TECHNICAL MANUAL
32 AND 33
TELETYPEWRITER SETS
KEYBOARD SEND-RECEIVE (KSR)
RECEIVE-ONLY (RO)
AUTOMATIC SEND-RECEIVE (ASR)

- 1.001 This addendum supplements existing adjustments in Bulletin 273B, Volume 2, Change 5, and applies only to 33TN and 33TX ASR sets.
- 1.002 Adjustments on the following pages augment sections in Bulletin 273B, Volume 2, as follows:

BULLETIN 273B
VOL 2

ARMATURE SPRING TENSION

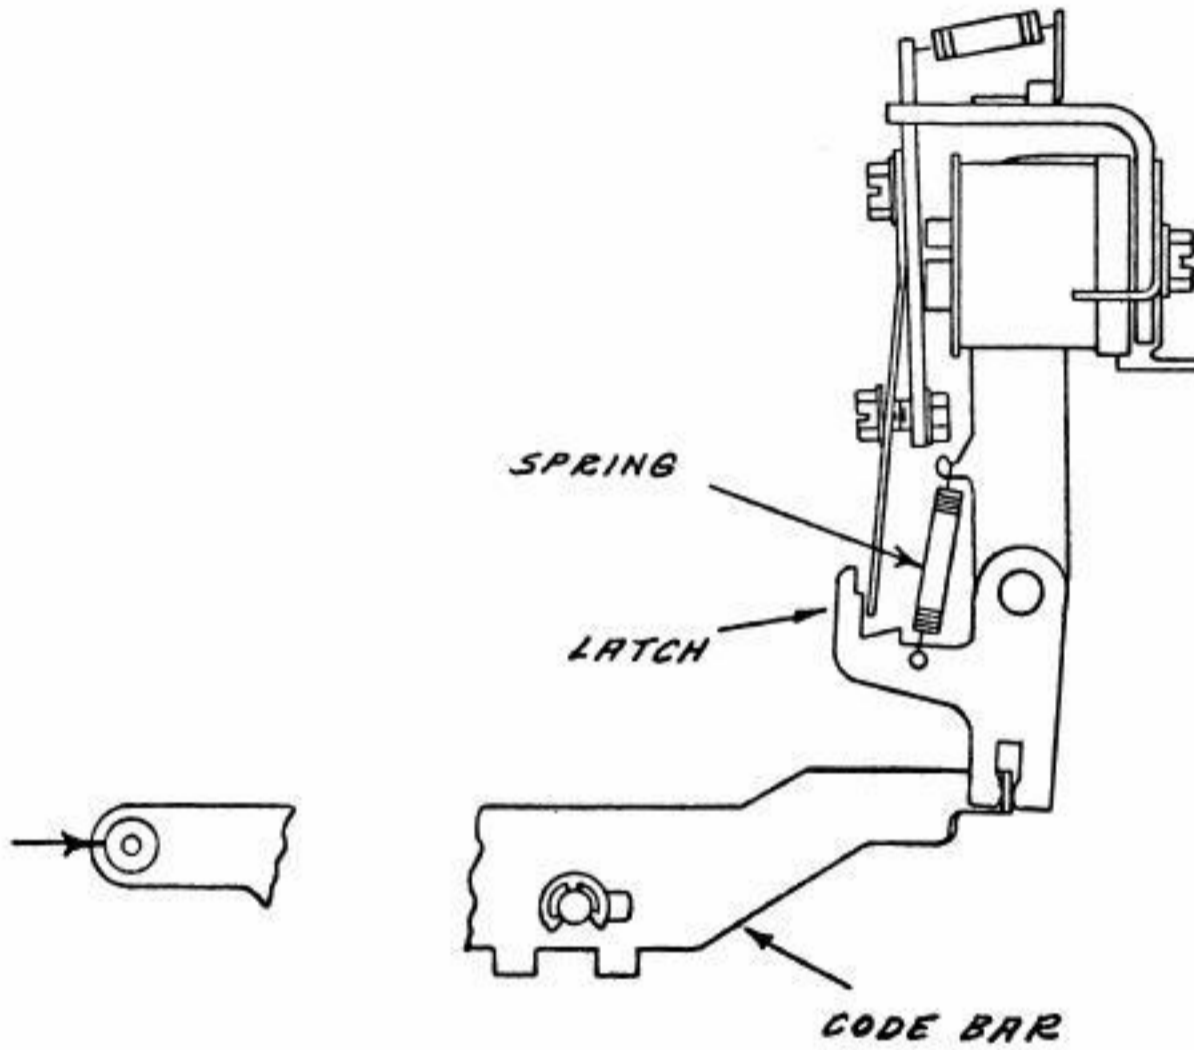
PRINTER "ON" TRIP ARMATURE SPRING TENSION (See Figure 6)

5.001 With the armature de-energized and holding the suppression codebar to the right, it shall take 2 to 3 oz to start the armature moving.

LATCH SPRING TENSION

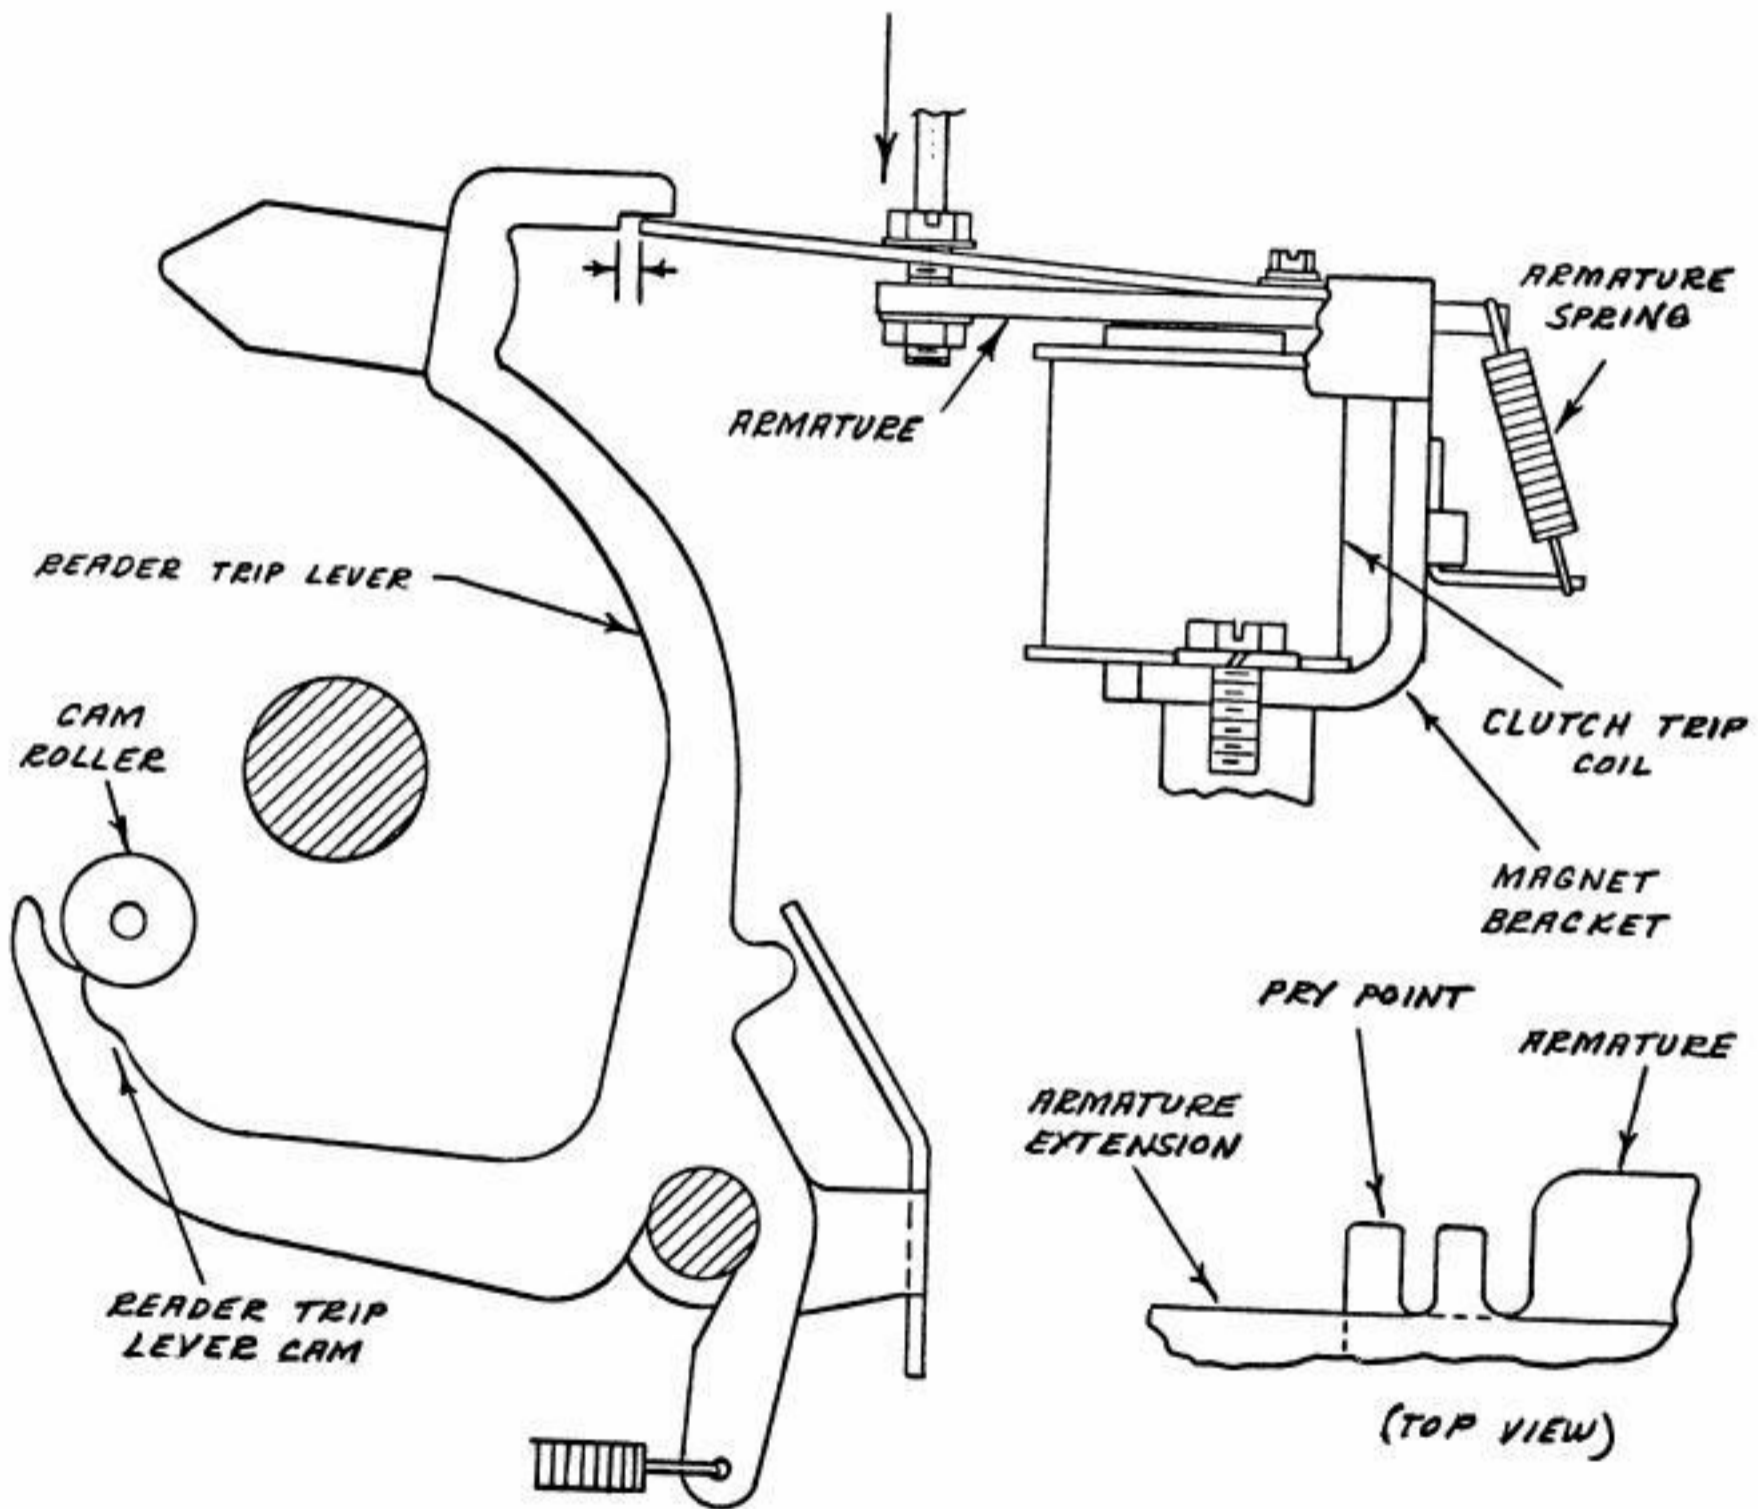
LATCH SPRING TENSION (See Figure 7)

5.002 With the latch disengaged, it shall take 2 to 3 oz to start the codebar moving.
